Docket Number:	13-AFC-01
Project Title:	Alamitos Energy Center
TN #:	201751
Document Title:	Data Adequacy Supplement
Description:	N/A
Filer:	Elizabeth Smoker
Organization:	CH2M HILL
Submitter Role:	Applicant Consultant
Submission Date:	2/17/2014 1:21:17 PM
Docketed Date:	2/18/2014

**Re: Alamos Energy Center (13-AFC-01)
Data Adequacy Supplement**

Data Adequacy Supplement

**Alamitos Energy Center
(13-AFC-01)**

IS061013112817SAC Figure_3.1-1aR.ai tdaus 02.07.2014

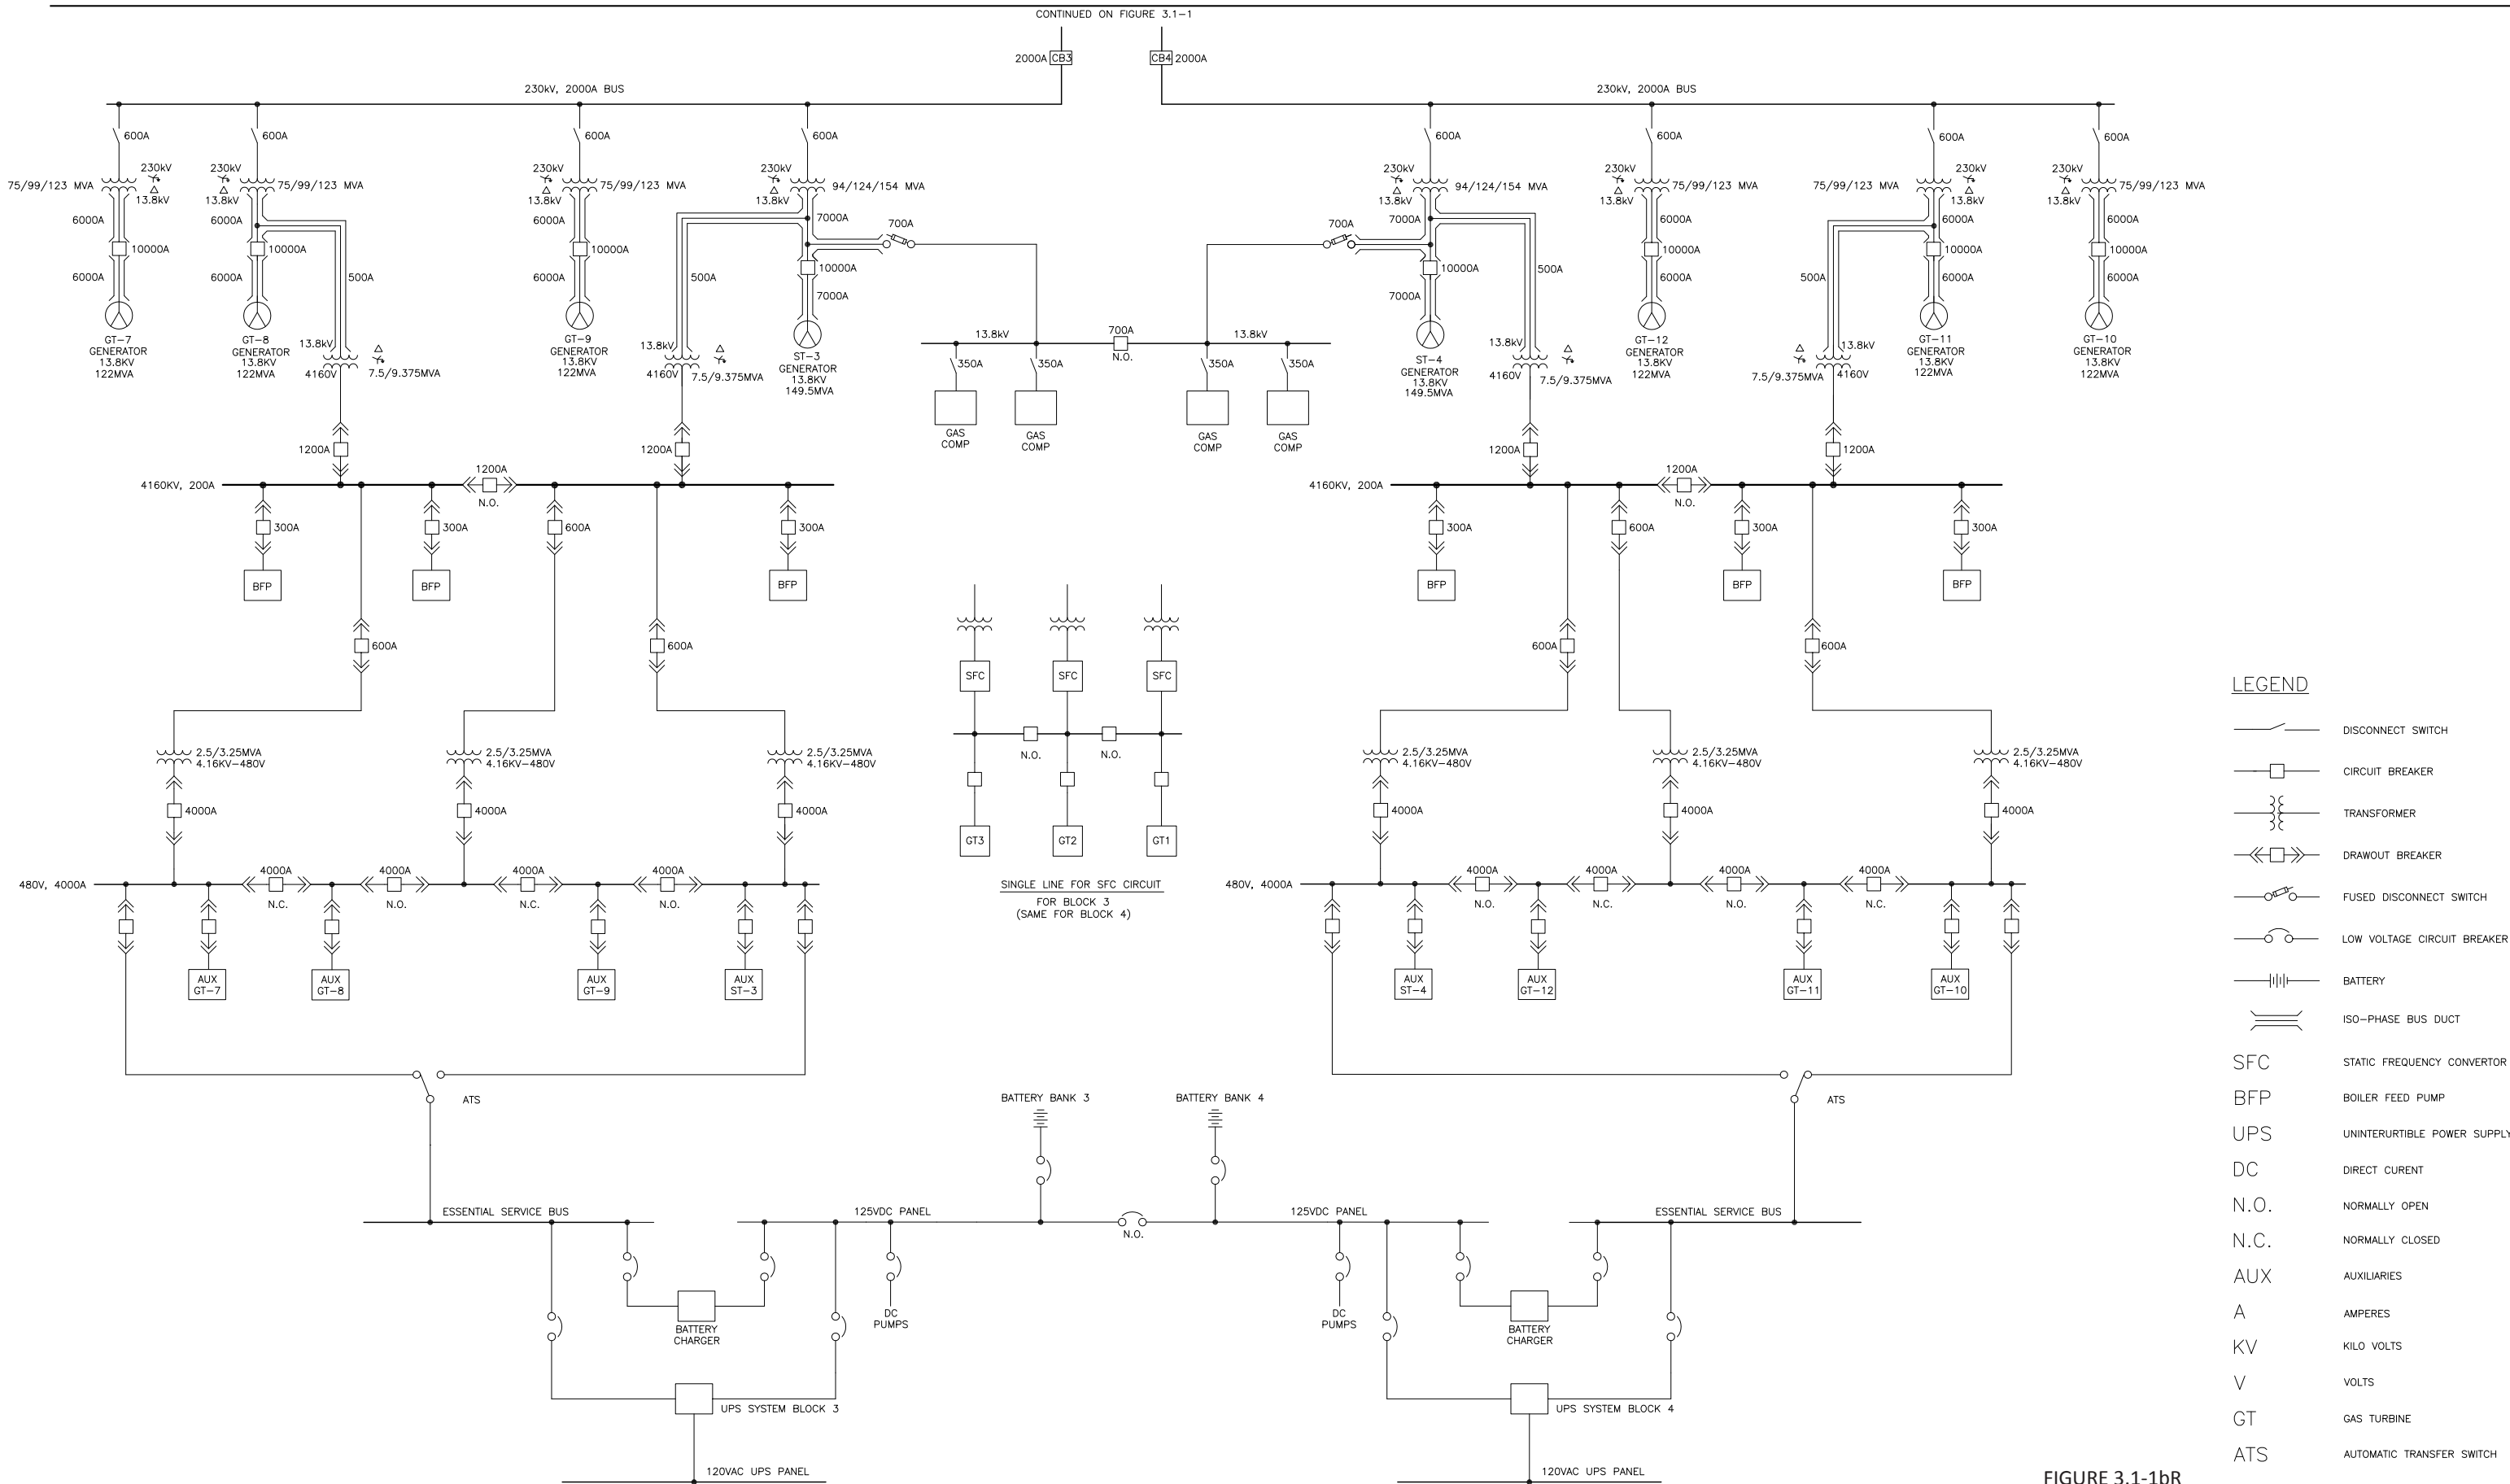
Resubmit Figs. 3.1-1a, 3.1-1b with the sizes and ratings of 13.8 kV bus duct connectors and any short overhead conductors between the high side of Generator Step-up transformers and 230 kV Disconnect switch.

Response: Revised Figures 3.1-1aR and 3.1-1bR show the sizes and ratings of the 13.8 kilovolt (kV) bus duct connectors and overhead conductors between the high side of the generator step-up transformer and the 230 kV disconnect switch.

FIGURE 3.1-1cR
System One Line Diagram – Power Block
to Switchyard
Alamitos Energy Center
Long Beach, California

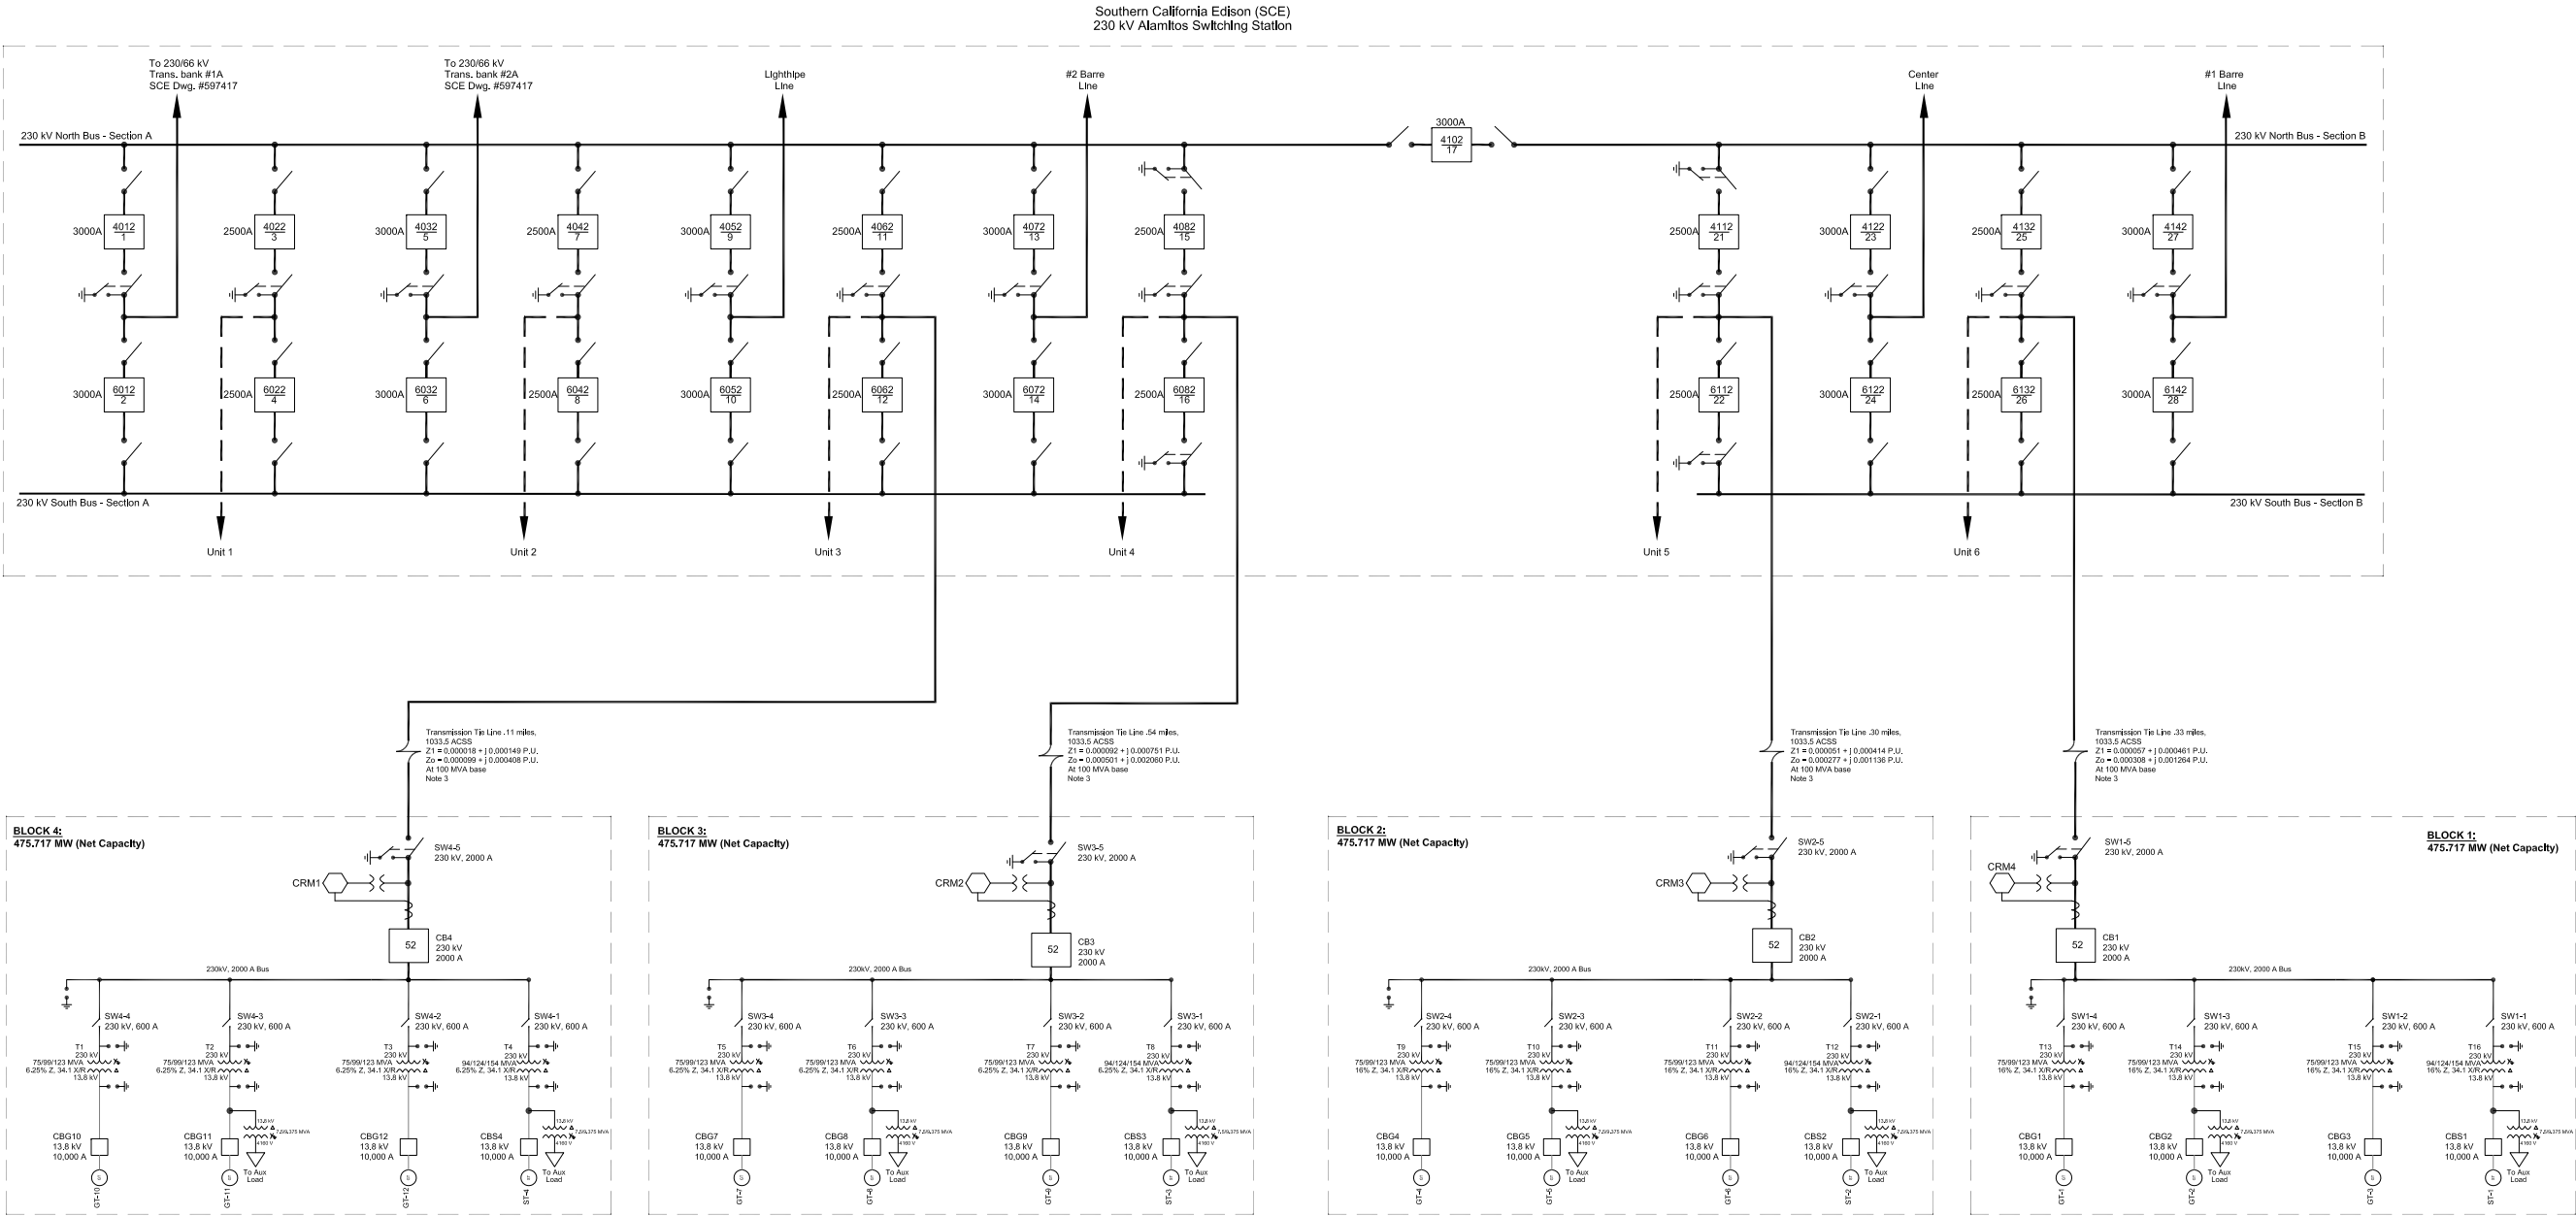
Resubmit Fig. 3.1-1c with the ratings of 230 kV Buses and 230 kV Breakers of SCE 230 kV switchyard connecting the 230 kV overhead Gen Tie lines of new generating units.

Revised Figure 3.1-1cR shows the ratings of 230 kV buses and 230 kV breakers of Southern California Edison (SCE) 230 kV switchyard where the AEC generating units interconnect with SCE switchyard.
